Work Order ID 132604

D3166-1 BASKET HOOP

DRAWING NO. D3166	TITLE BASKET HOOP	REV A1	DART AEROSPACE LTD ENGINEERING ORDER		D.E.O. NO. D3166-A-2	SHEET NO. 1 OF 1	SCALE NTS
DRAWN AJS	CHECKED [Signature]	MFG. APPR. [Signature]	APPROVED [Signature]		DE APPR. [Signature]		
DATE 08.12.11	DATE 08.12.15	DATE 08/12/15	DATE 08/12/16		DATE 08.12.16

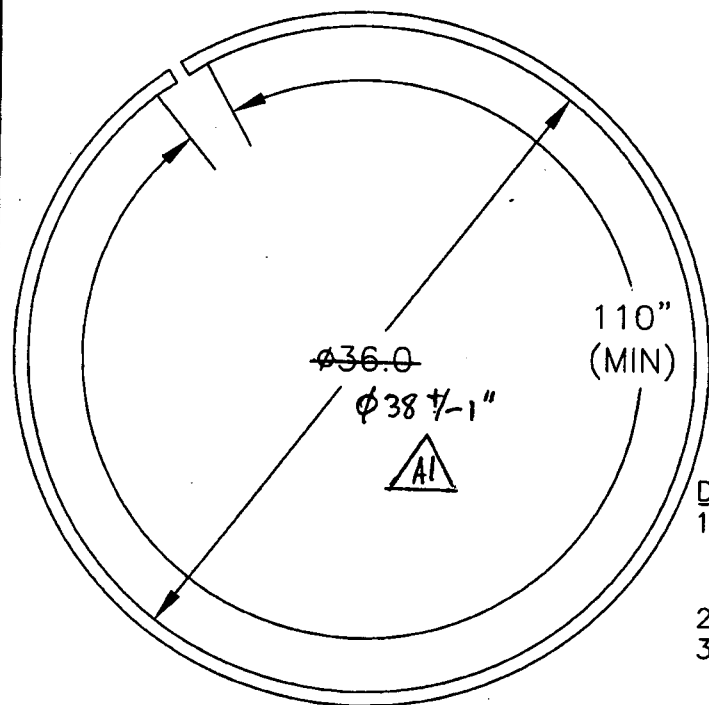
1) MODIFY MATERIAL NOTE FOR D3166-1 AS SHOWN:

IS:

1) MATERIAL: AISI 304/316 SS, 3/4 X 3/4 X 0.065 WALL SQUARE TUBING,
60.00" LONG
REF. DART SPEC M304TS0.750W.065

WAS:

1) MATERIAL: AISI 304/316 SS SQUARE TUBING,
0.75" x 0.75" x 0.063 WALL, 60.00" LONG
(REF DART SPEC. M304TS0.750W.063)

2) MODIFY MATERIAL NOTE FOR D3166-3 AS SHOWN:

IS:

1) MATERIAL: AISI 304/316 SS, 3/4 X 3/4 X 0.065 WALL SQUARE TUBING,
120.00" LONG
REF. DART SPEC M304TS0.750W.065

WAS:

1) MATERIAL: AISI 304/316 SS SQUARE TUBING,
0.75" x 0.75" x 0.063 WALL, 120.00" LONG
(REF DART SPEC. M304TS0.750W.063)

REASON: SEE PAR 08-005
